DSOX95004Q-01

S E R V I C E N O T E

DSOX95004Q Infiniium High-Performance Oscilloscope: 50 GHz

Example of the data flyers:

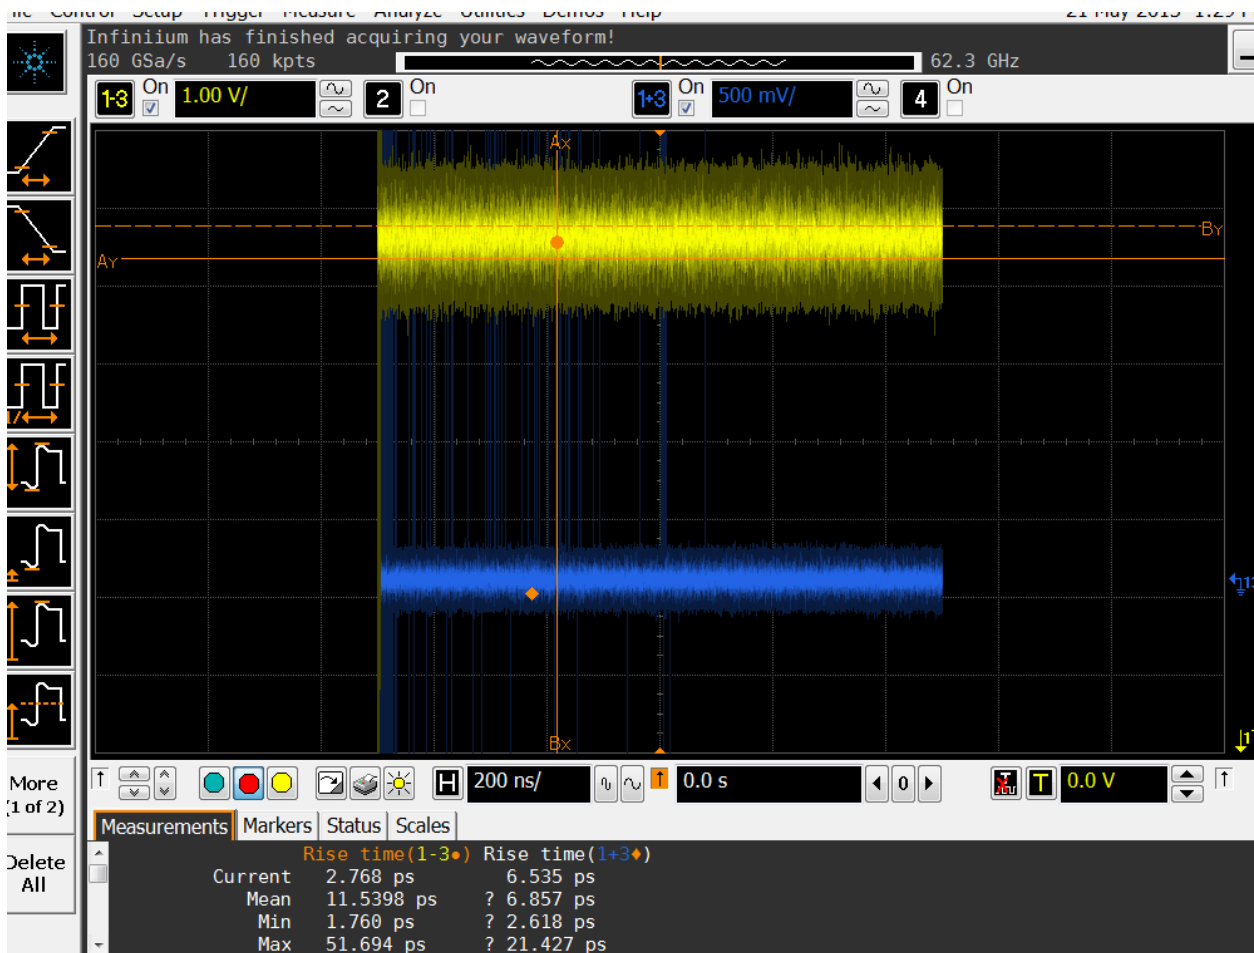
Using the Real Channels with differential mode on and or Precision Probe on, causes the Main FPGA to dip and data fryers are observed due to voltage variations.

Starting in July 2013 week 33 and ECO was implemented changing the power supplied to the Main FPGA. This fixed the Real channels having Data Flyers due to voltage variations. Scopes shipped previous to this ECO need to be updated to the reworded Backplane assembly.

Replace Backplane assembly following the service manual procedure. Factory Calibration is required after the backplane replacement.
